PIC24FJ128GA204 Family Silicon Errata and Data Sheet Clarification

The PIC24FJ128GA204 family devices that you have received conform functionally to the current Device Data Sheet (DS30010038B), except for the anomalies described in this document.

FIGURE 1: UPDATED PACKAGE MARKINGS

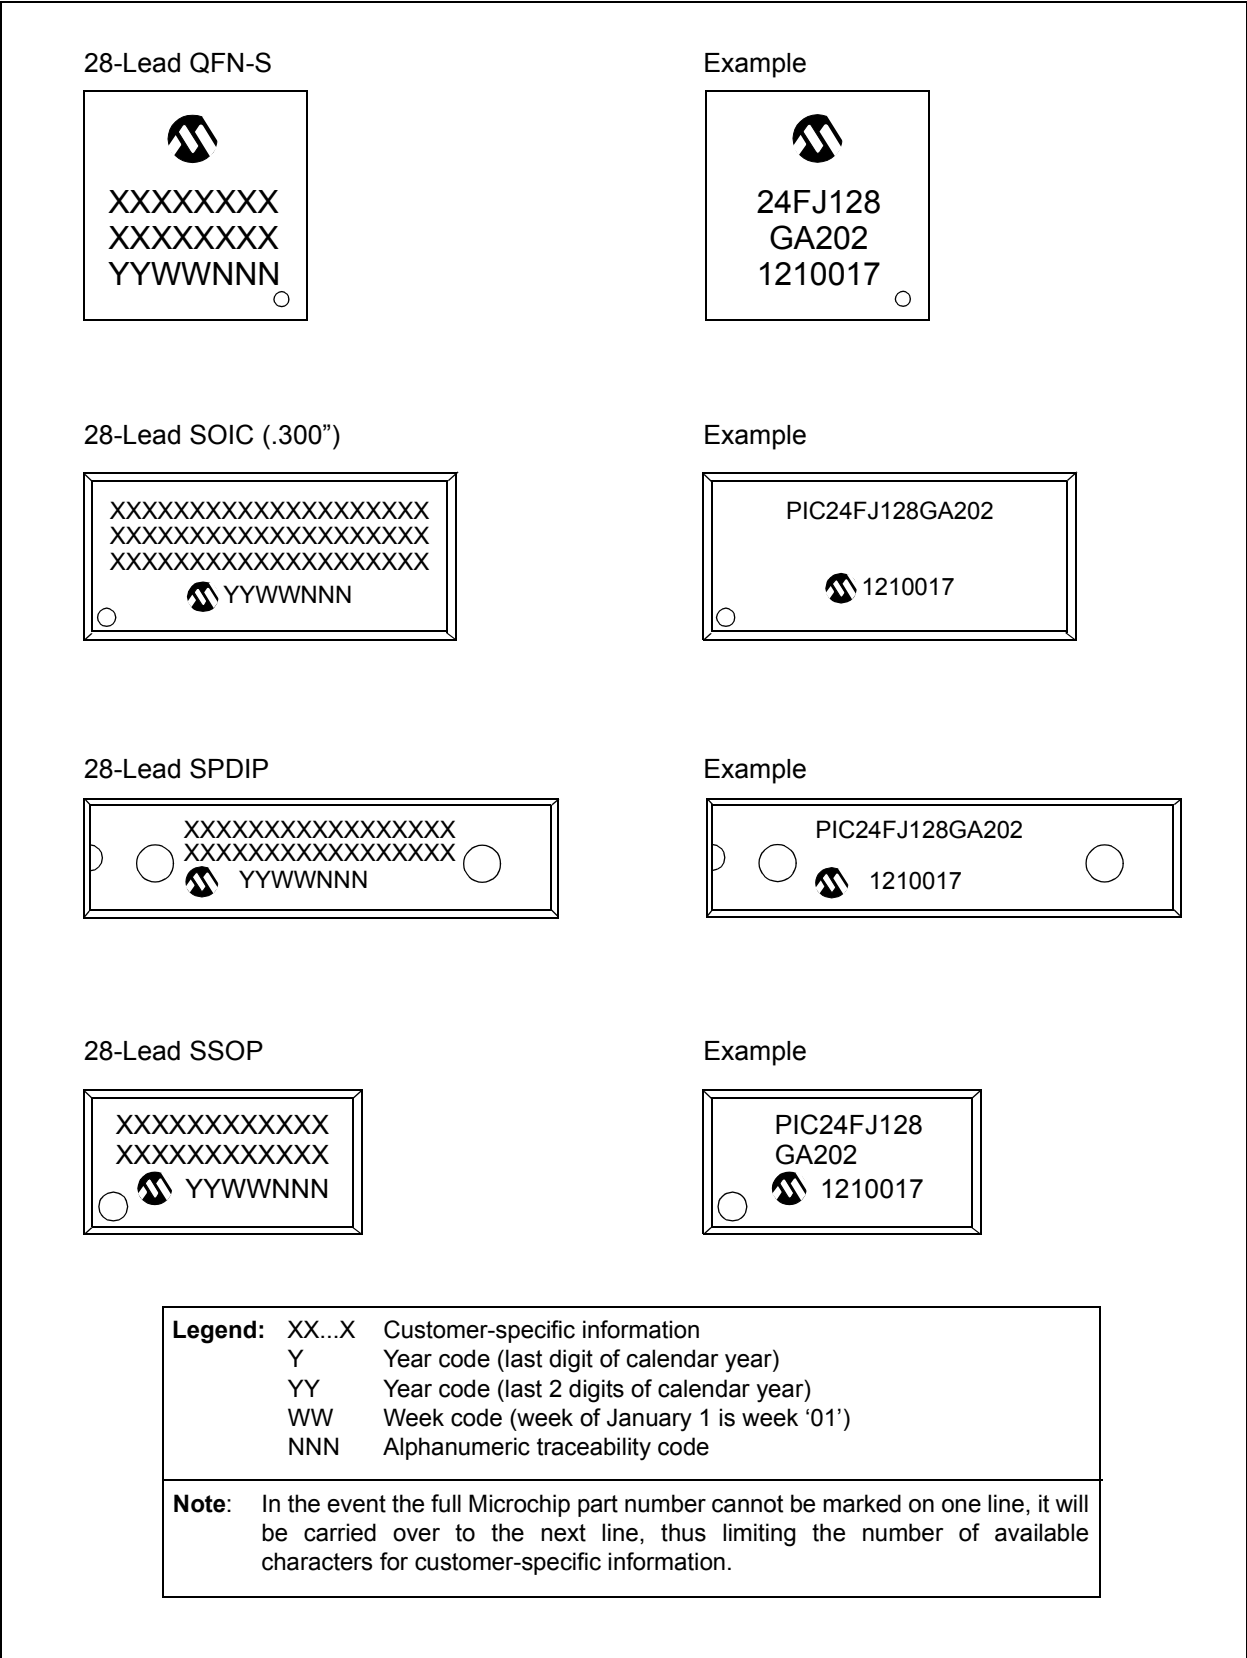
The package markings for all PIC24FJ128GA204 family devices have changed. Package markings are now limited to the short part number, manufacturing date code, trace code and Microchip trademark (where space is available). The operating temperature code and packaging code have been removed from the marking as redundant.

The diagrams in **Section 33.1 “Package Marking Information”** are changed, as shown in [Figure 1](#) and [Figure 2](#) (following pages), to reflect these modifications.
